SUNDRY NOTICES AND REPORTS ON WELLS ALBUQUERQUE.

8. Well Name and No.  
BADLANDS FLAT FED #1

Badland Flats Federal #1  
Plugging Procedure

CONDITIONS OF APPROVAL FOR PERMANENT ABANDONMENT

Well: Badland Flats Fed. #1

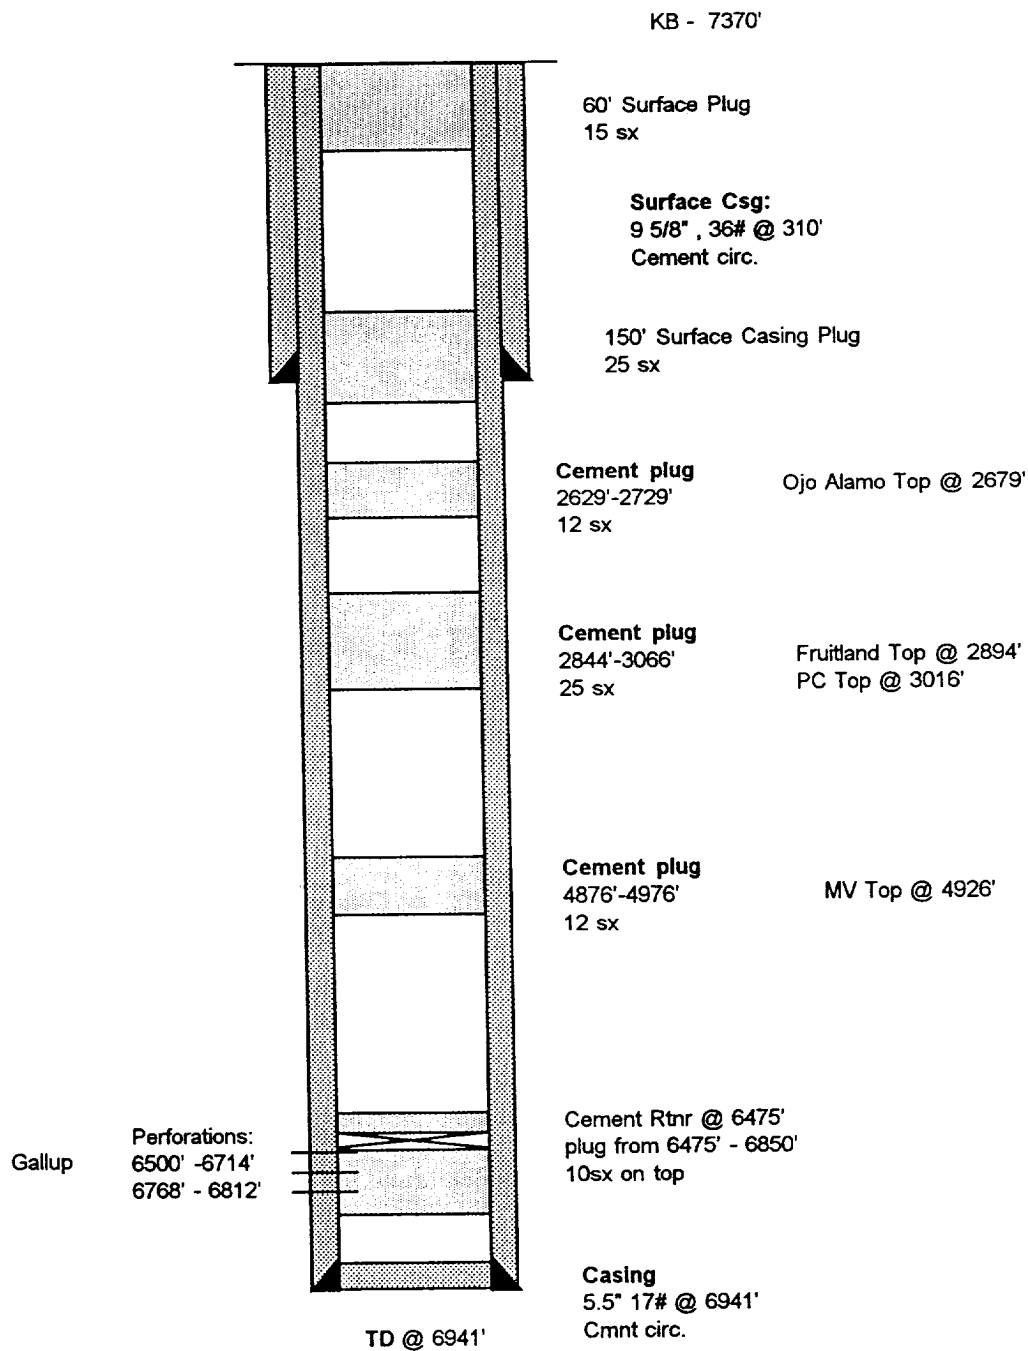
An additional 12sx plug will be placed from 1478'-1578' across the top of the Nacimiento formation.
